# UNITED STATES PATENT AND TRADEMARK OFFICE

**Office Action Summary****Application No.**

10/527,395

## DETAILED ACTION

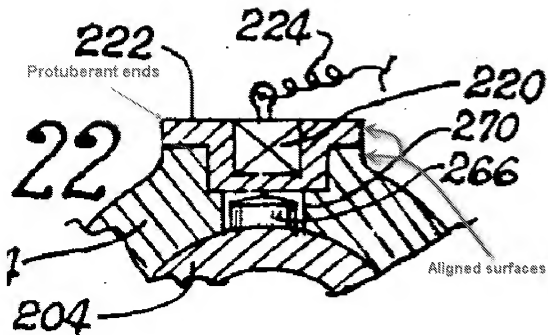
a protector (19) comprising at least one sensor cavity, **see FIG. 2 below as adapted by examiner**, for associating an inductive sensor;

a sensor being installed on a protector, **FIG. 2 shows a position sensing device (14, 15, 16, 17, 20), being fixed to the right against a protector (19);**

limitations from claim 8, a sensor is fixed to the closed portion of the protector, **FIG. 2 shows a position sensing device (14, 15, 16, 17, 20), being fixed to the right against a protector (19);**

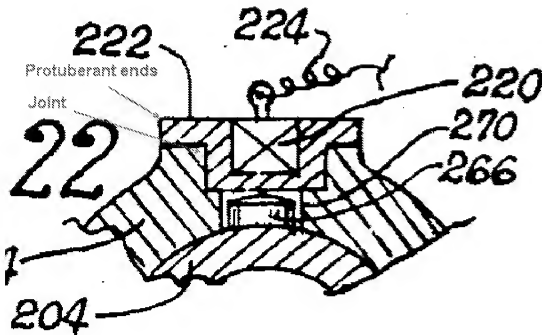
a sensor, FIG. 22 (220) C. 12 Lines 22-23, and a protector, FIG. 22 (222) C. 12 Lines 23-25, comprising protuberant ends, **as seen below in FIG. 22 as adapted by the examiner, forming a joint;**

**FIG. 1**

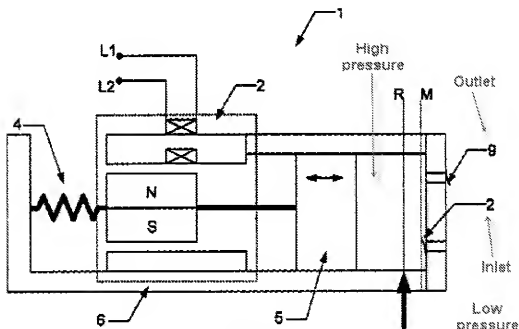
limitations from claim 5, a valve plate, **FIG. 1 (9) C. 4 Line 35**, comprises a suction valve associated with a low-pressure environment and a discharge valve associated with a high-pressure environment, **see FIG. 1 below as adapted by the examiner**;

**When combined, the sensor and protector taught by Hvilsted and the valves taught by Schwarz will be associated with the same high and low pressure environments on either side of a plate (~9).**
